FINAL DRAINAGE REPORT FOR CLAREMONT BUSINESS PARK 2 FILING NO. 2 EL PASO COUNTY, COLORADO

February 2023

Project #10-020
PCD Filing No.: VR233 k

DETENTION BASIN STAGE-STORAGE TABLE BUILDER

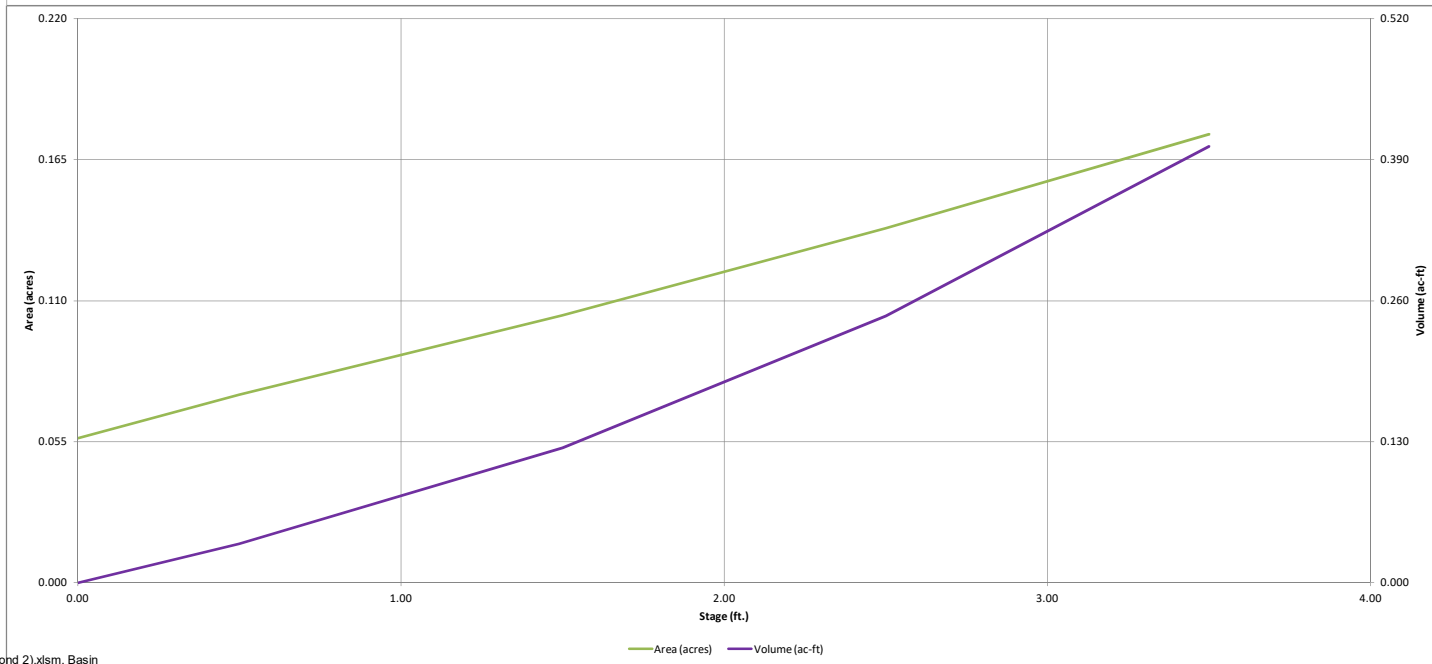
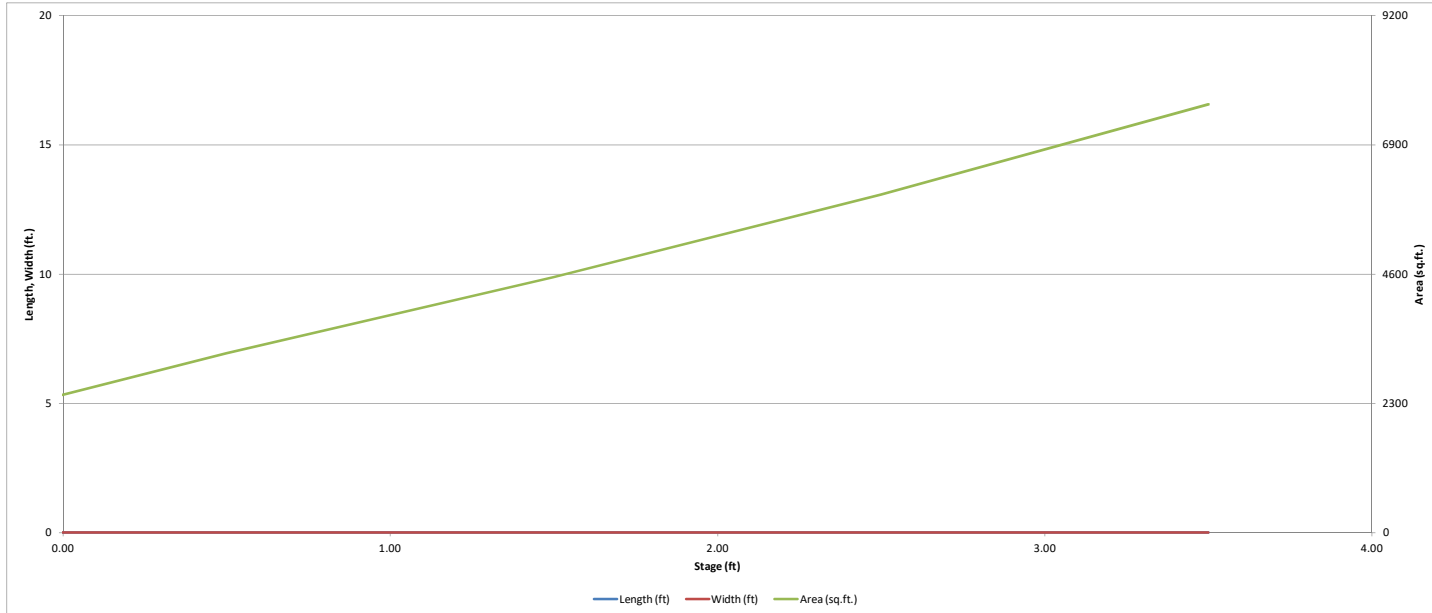
Add text to the PDF at the top of all calc sheets of ponds that aren't to be constructed with this project (ie: just the roads and Pond 3) that these "CALCS PROVIDED FOR INFORMATION ONLY, POND # [insert "1," "2," "4", and "5" as appropriate] TO BE DESIGNED AND CONSTRUCTED WITH FUTURE DEVELOPMENT"

SHEET LABELED EXISTING CONDITION AND CORRESPONDING SHEET LABEL PROPOSED CONDITION EXTENTION OF EL JEFE HT.

TEXT ADDED TO REPORT, EX POND NOT TO BE MODIFIED OR CALCS PROVIDED FOR INFORMATION ONLY, POND# TO BE DESIGNED AND CONSTRUCTED WITH FUTURE DEVELOPMENT

DETENTION BASIN STAGE-STORAGE TABLE BUILDER

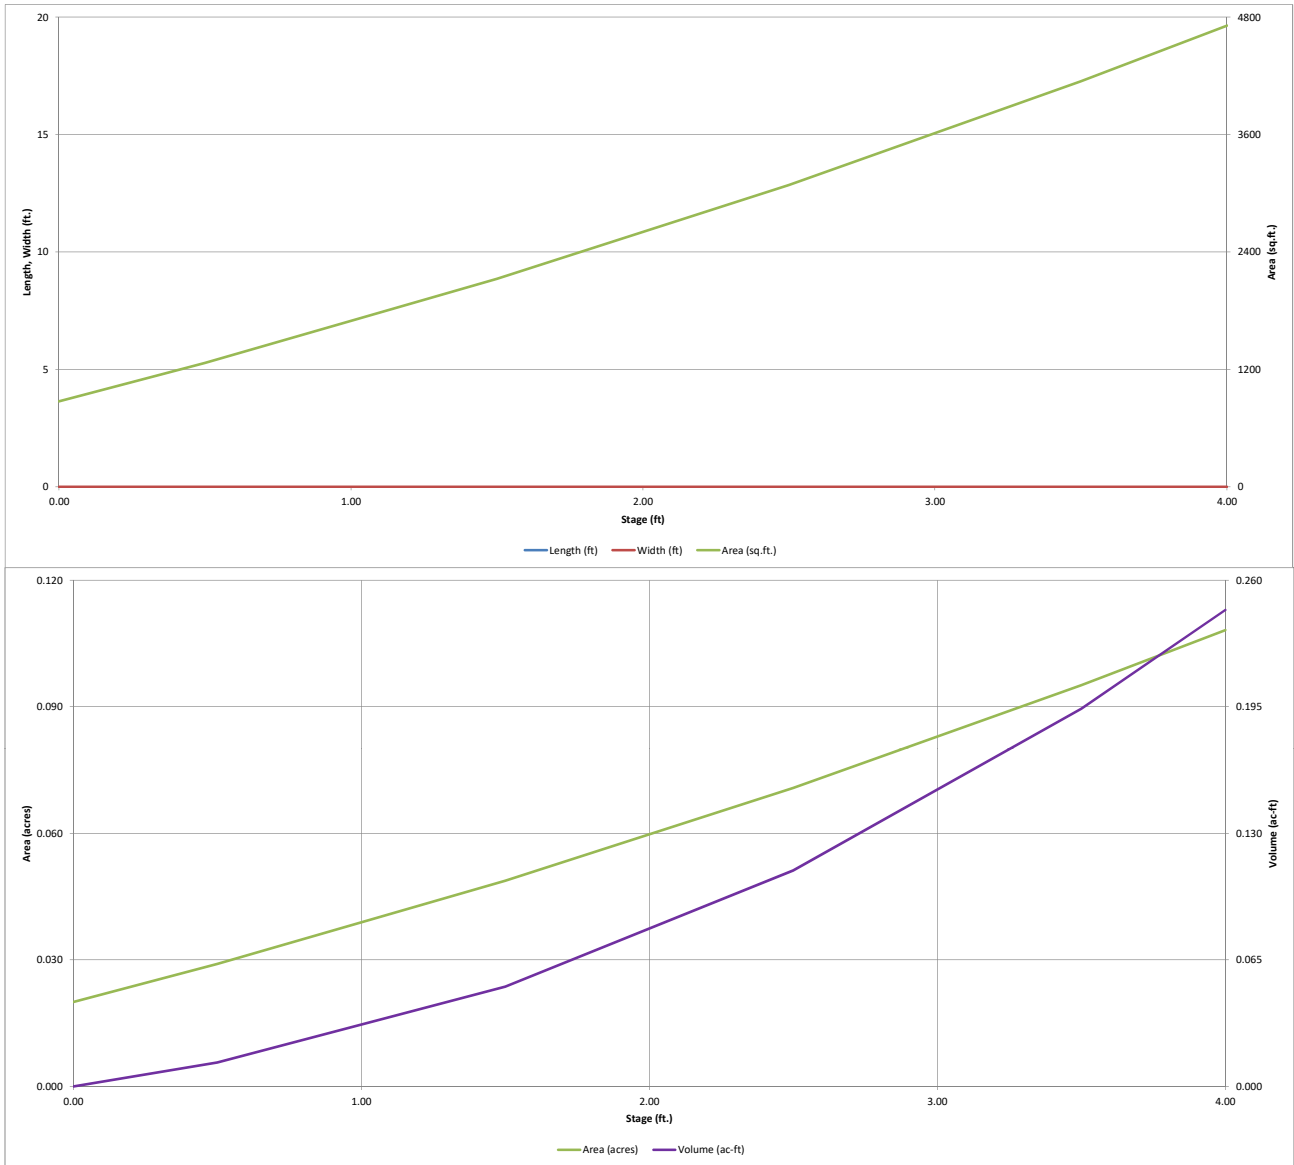
Add text to the PDF at the top of all calc sheets of ponds that aren't to be constructed with this project (ie: just the roads and Pond 3) that these "CALCS PROVIDED FOR INFORMATION ONLY, POND # [insert "1," "2," "4", and "5" as appropriate] TO BE DESIGNED AND CONSTRUCTED WITH FUTURE DEVELOPMENT"

TEXT ADDED TO REPORT, EX POND NOT TO BE MODIFIED OR CALCS PROVIDED FOR INFORMATION ONLY, POND# TO BE DESIGNED AND CONSTRUCTED WITH FUTURE DEVELOPMENT

DETENTION BASIN STAGE-STORAGE TABLE BUILDER

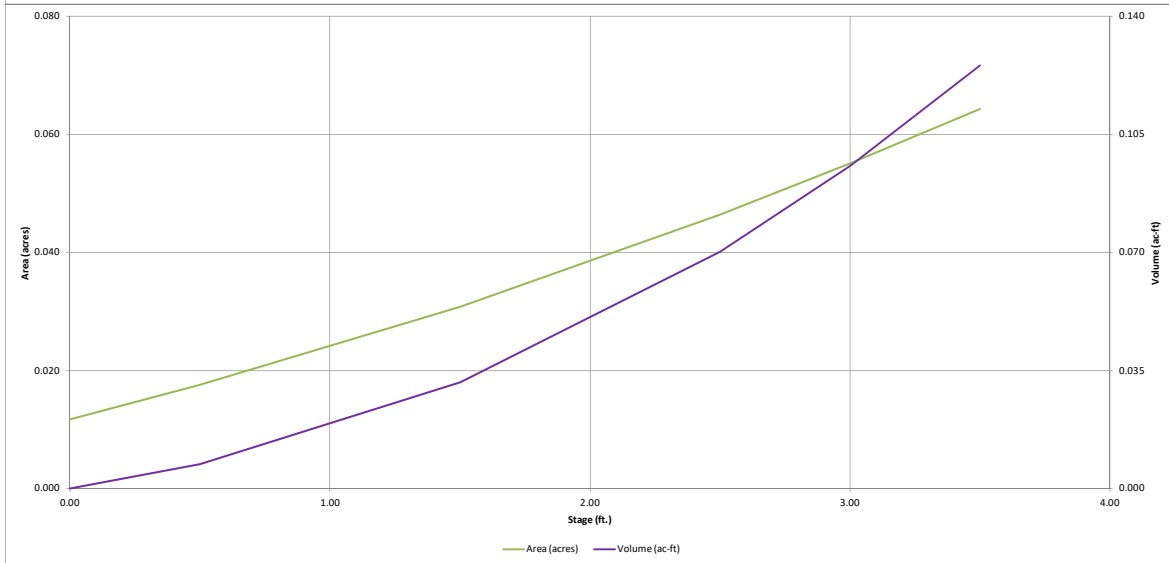
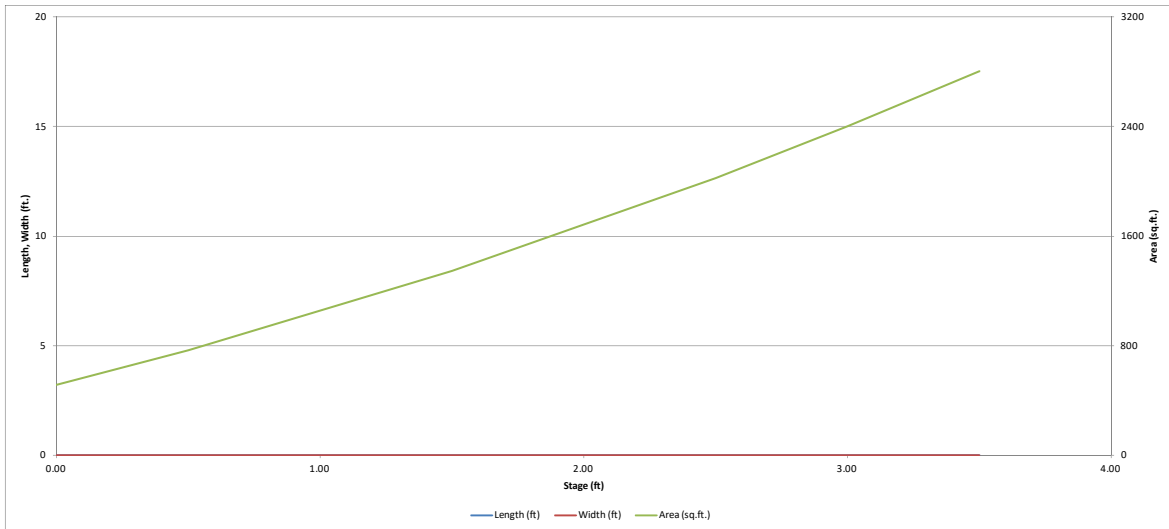
Add text to the PDF at the top of all calcd sheets of ponds that aren't to be constructed with this project (ie: just the roads and Pond 3) that these "CALCS PROVIDED FOR INFORMATION ONLY, POND # [insert "1," "2," "4", and "5" as appropriate] TO BE DESIGNED AND CONSTRUCTED WITH FUTURE DEVELOPMENT"

TEXT ADDED TO REPORT, EX POND NOT TO BE MODIFIED OR CALCS PROVIDED FOR INFORMATION ONLY, POND# TO BE DESIGNED AND CONSTRUCTED WITH FUTURE DEVELOPMENT

DETENTION BASIN STAGE-STORAGE TABLE BUILDER

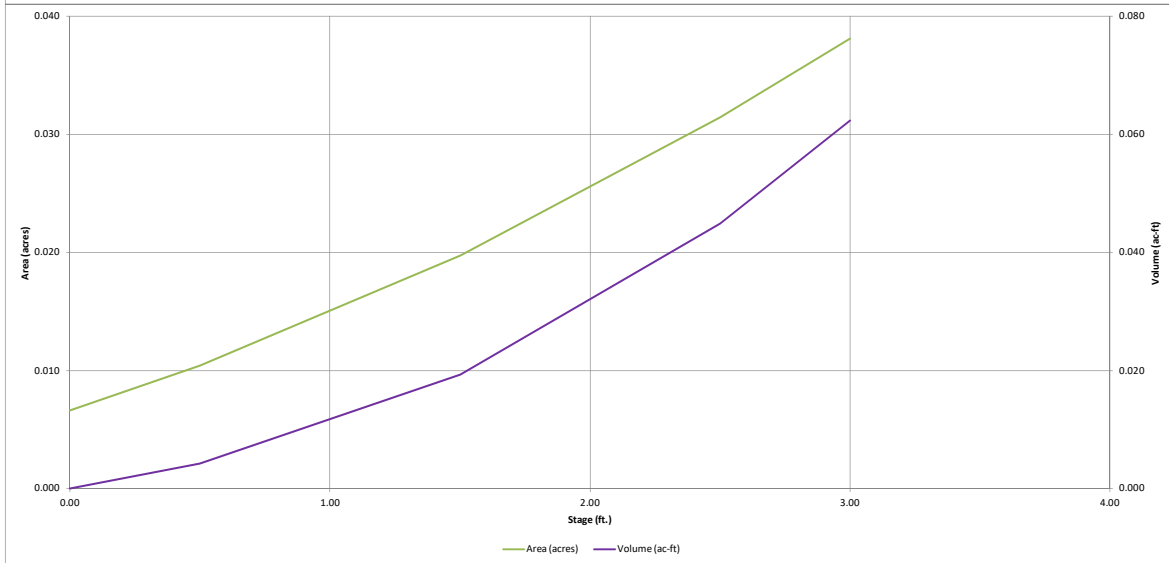
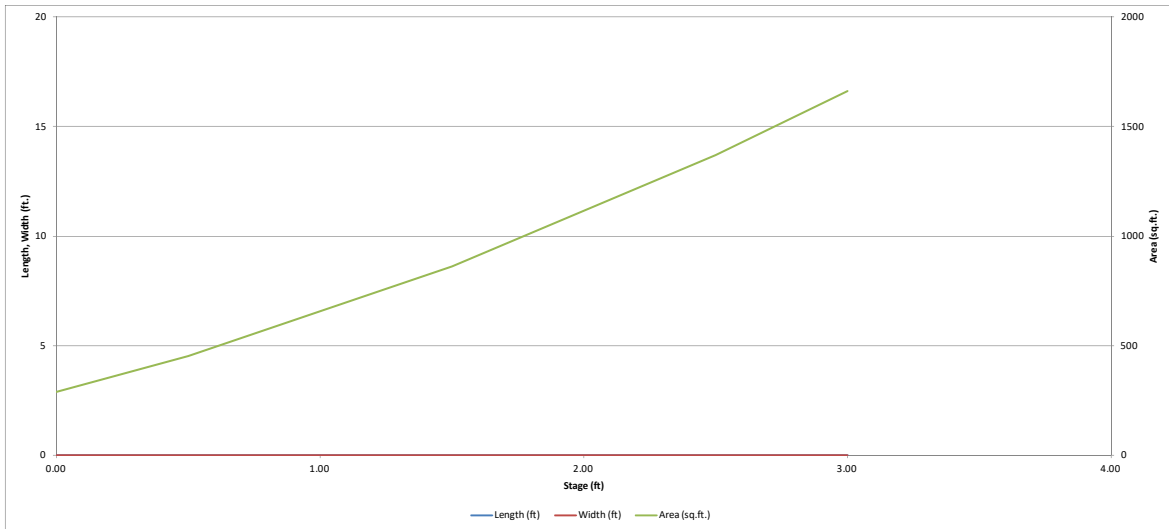
Add text to the PDF at the top of all calc sheets of ponds that aren't to be constructed with this project (ie: just the roads and Pond 3) that these "CALCS PROVIDED FOR INFORMATION ONLY, POND # [insert "1," "2," "4", and "5" as appropriate] TO BE DESIGNED AND CONSTRUCTED WITH FUTURE DEVELOPMENT"

TEXT ADDED TO REPORT, EX POND NOT TO BE MODIFIED OR CALCS PROVIDED FOR INFORMATION ONLY, POND# TO BE DESIGNED AND CONSTRUCTED WITH FUTURE DEVELOPMENT

DETENTION BASIN STAGE-STORAGE TABLE BUILDER

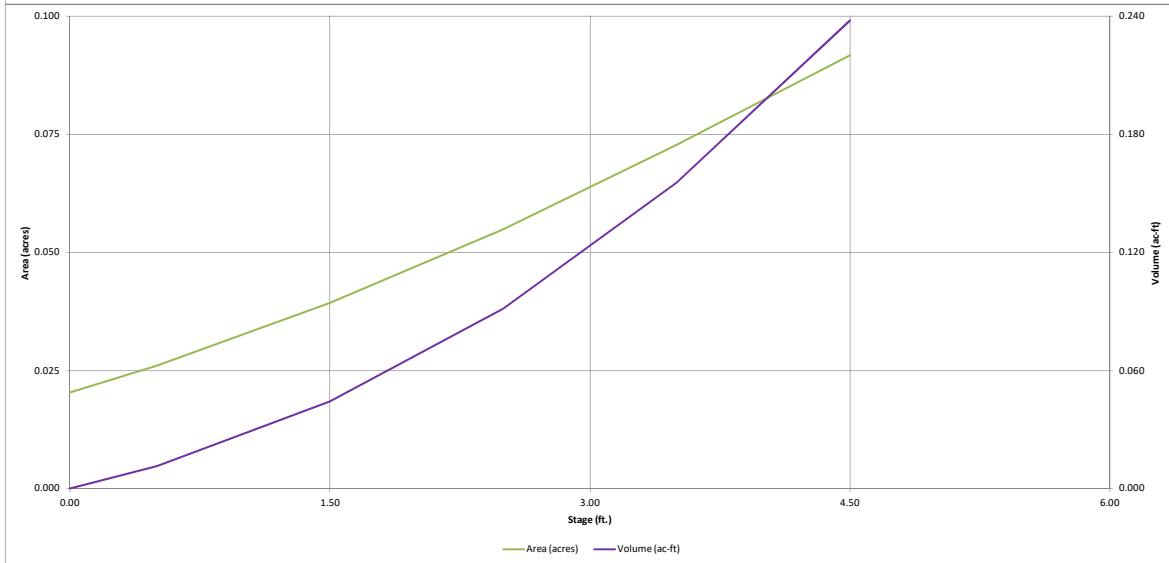
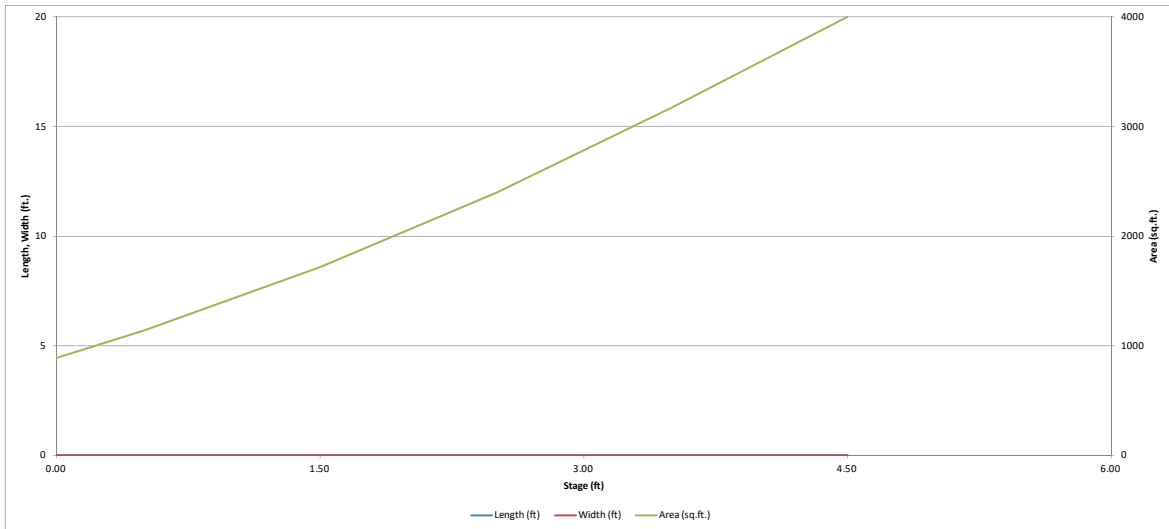
Add text to the PDF at the top of all calcd sheets of ponds that aren't to be constructed with this project (ie: just the roads and Pond 3) that these "CALCS PROVIDED FOR INFORMATION ONLY, POND # [insert "1," "2," "4", and "5" as appropriate] TO BE DESIGNED AND CONSTRUCTED WITH FUTURE DEVELOPMENT"

TEXT ADDED TO REPORT, EX POND NOT TO BE MODIFIED OR CALCS PROVIDED FOR INFORMATION ONLY, POND# TO BE DESIGNED AND CONSTRUCTED WITH FUTURE DEVELOPMENT

DETENTION BASIN STAGE-STORAGE TABLE BUILDER

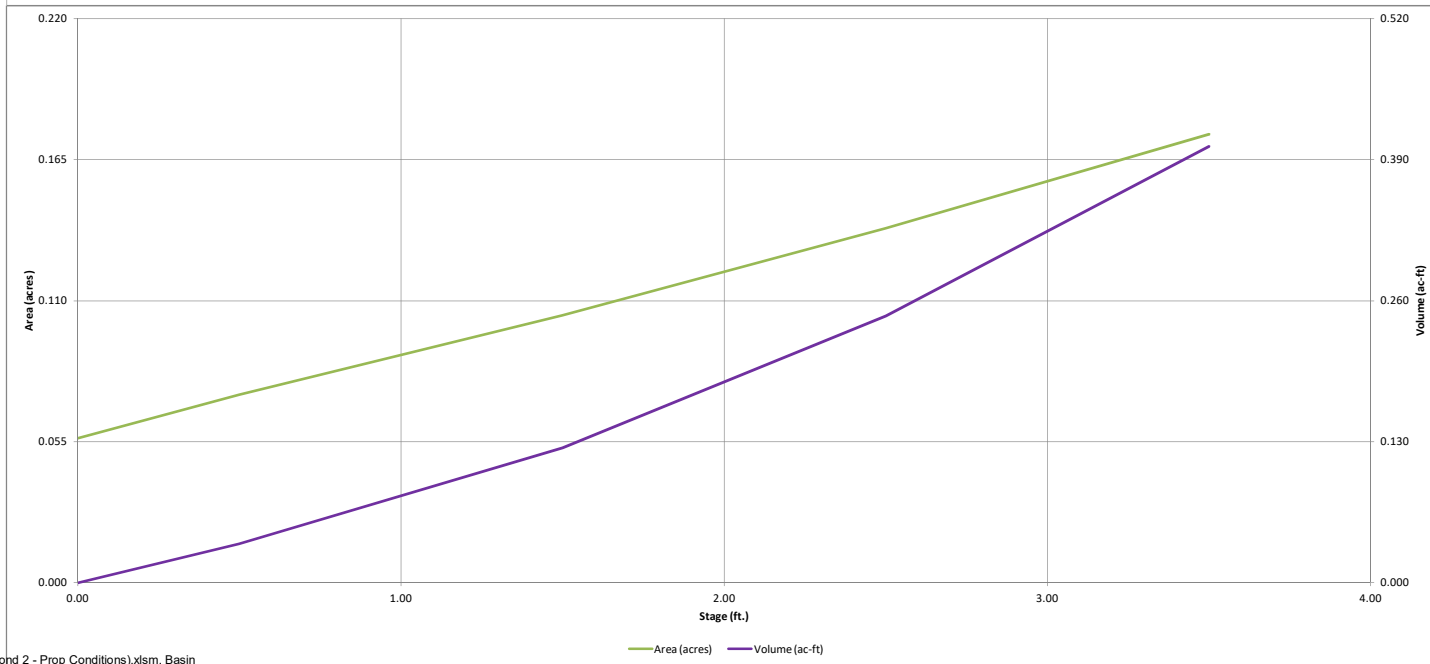
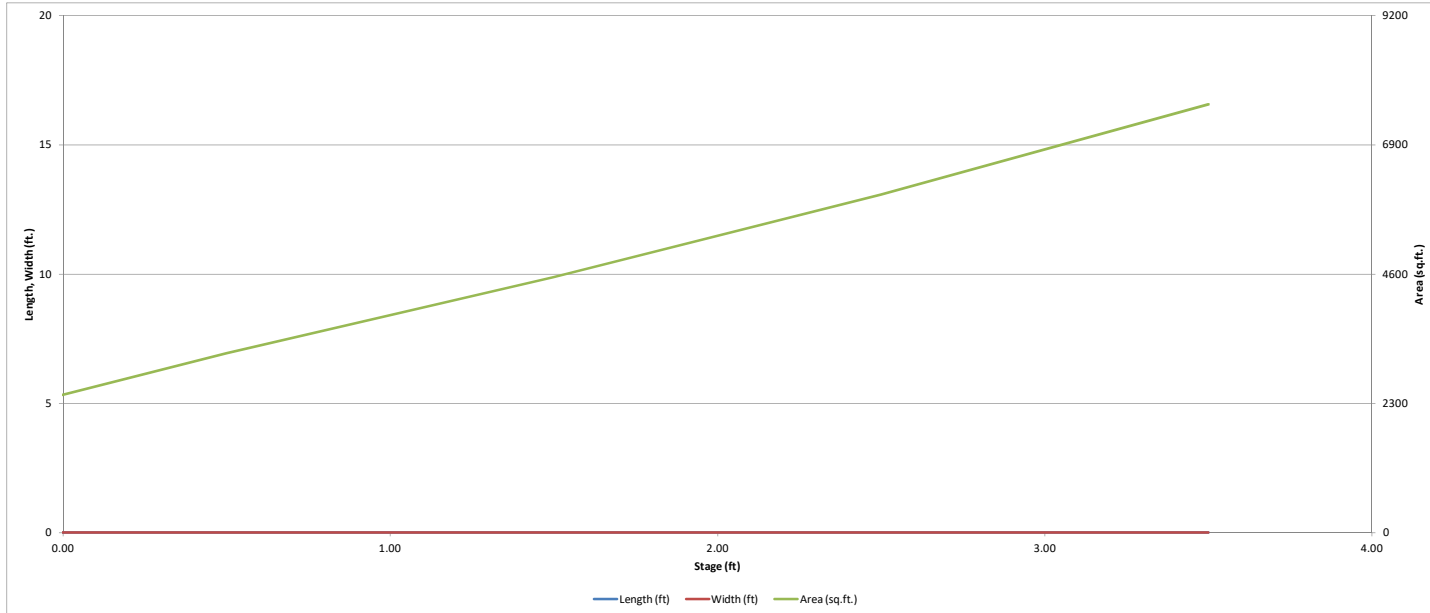
Define "Remodeled Proposed Conditions."
 How is this different for the other calcs for this same pond shown on pdf page 60 above?
 Please discuss in the FDR text above.

DETENTION BASIN OUTLET STRUCTURE SHEET LABELED EXISTING CONDITION AND CORRESPONDING SHEET LABEL OF EL JEFE HT.

Storm 1 - Lat 1 - 100 yr

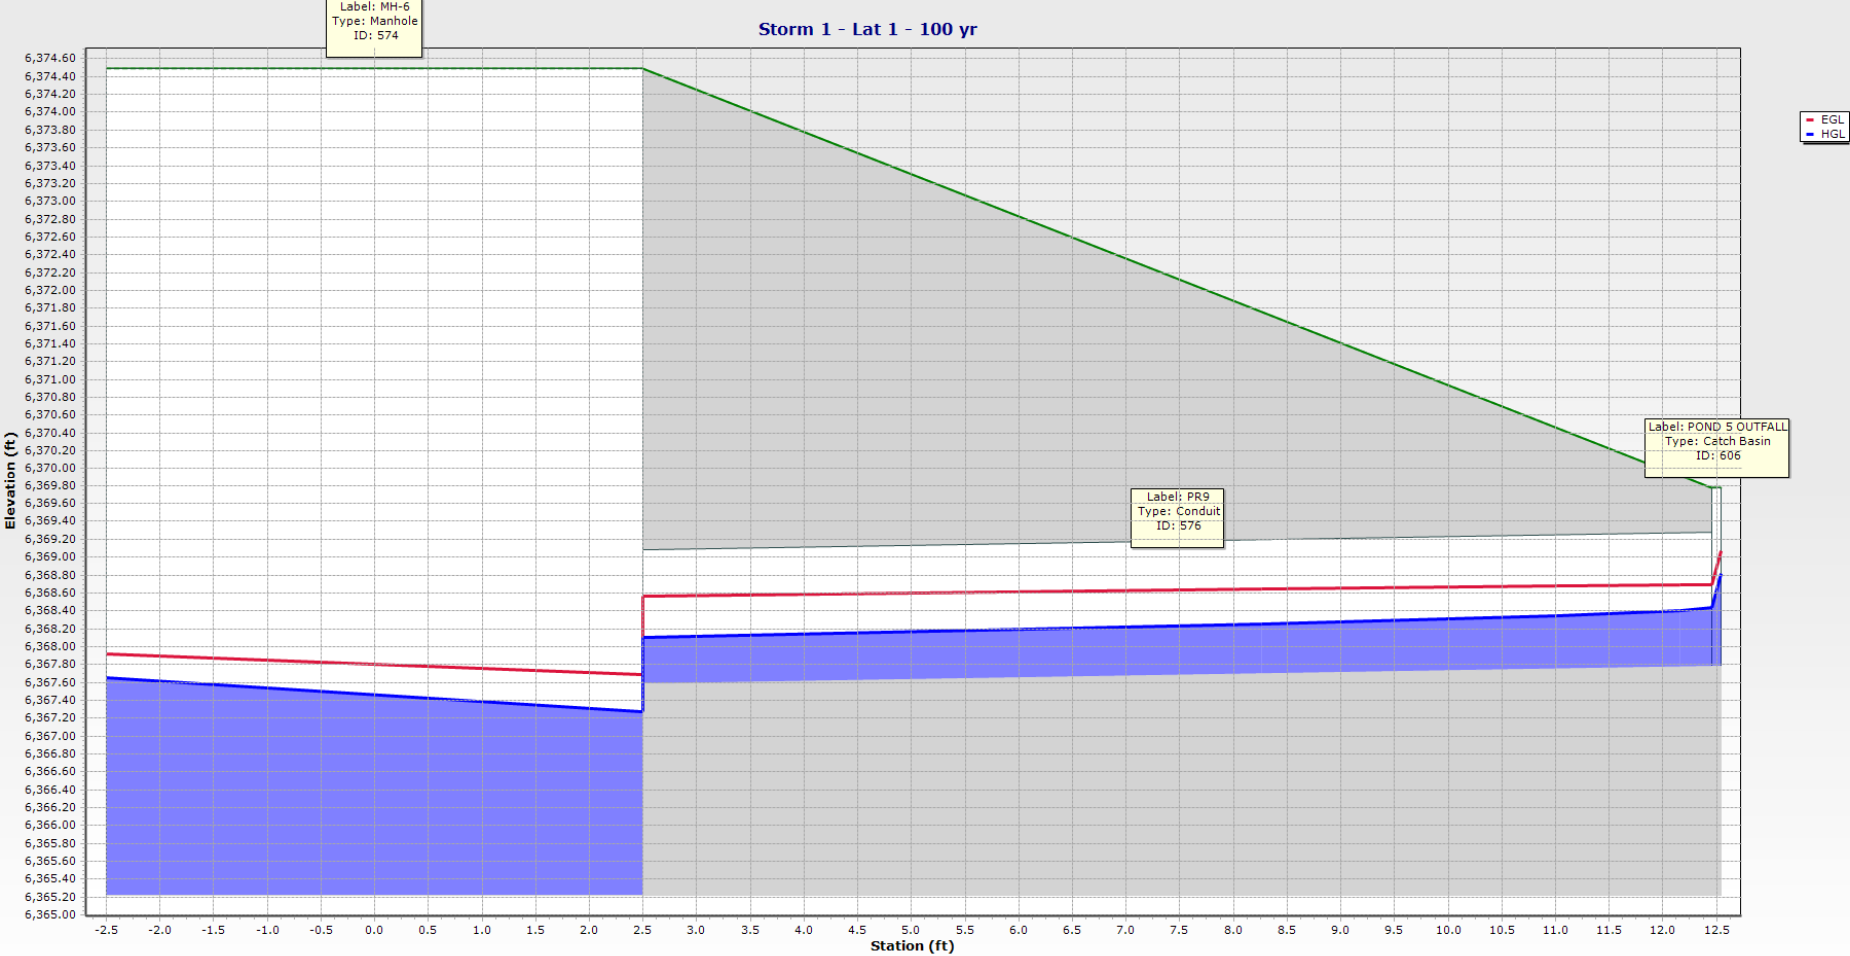
Try to print all of stormcad table on one sheet, or include "Label" column with second sheet

**STORM CAD INFORMATION
PRINTED ON ONE SHEET**
